Product / Process Change Notice

Chip process CP209, N-Channel JFETS, wafers and bare die.

PCN #221
Notification Date:
June 17, 2021

Figure 1: CP209 Chip Geometry (Discontinued)

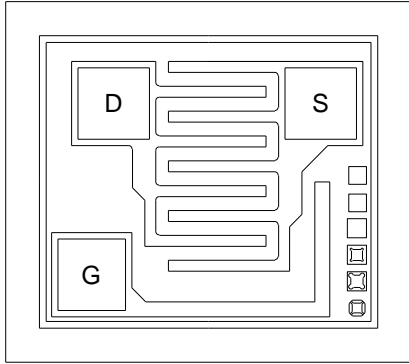
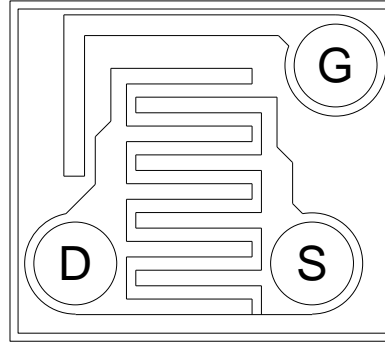
The CP209 wafer process has been discontinued and is being replaced with the CP264V wafer process. See Figures 1 and 2 for details.

The CP209 wafer process has been replaced in order to enhance manufacturing process controls and device performance. This change will help to ensure an undisrupted supply of product.

The CP264V wafer process meets all electrical specifications of the individual devices listed on the following page.

Wafer Diameter: 5 inch
Die Size: 18 x 16 mils
Die Thickness: 7.9 mils
Bond Pad Size (Drain): 3.0 x 3.0 mils
Bond Pad Size (Source): 3.0 x 3.0 mils
Bond Pad Size (Gate): 3.0 x 3.0 mils
Topside Metal: Al-Si (17,000Å)
Backside Metal: Au (12,000Å)

Wafer Diameter: 5 inch
Die Size: 17.1 x 15.1 mils
Die Thickness: 7.9 mils
Bond Pad Size (Drain): 3.7 mils Diameter
Bond Pad Size (Source): 3.7 mils Diameter
Bond Pad Size (Gate): 3.7 mils Diameter
Topside Metal: Al-Si (17,000Å)
Backside Metal: Au (12,000Å)
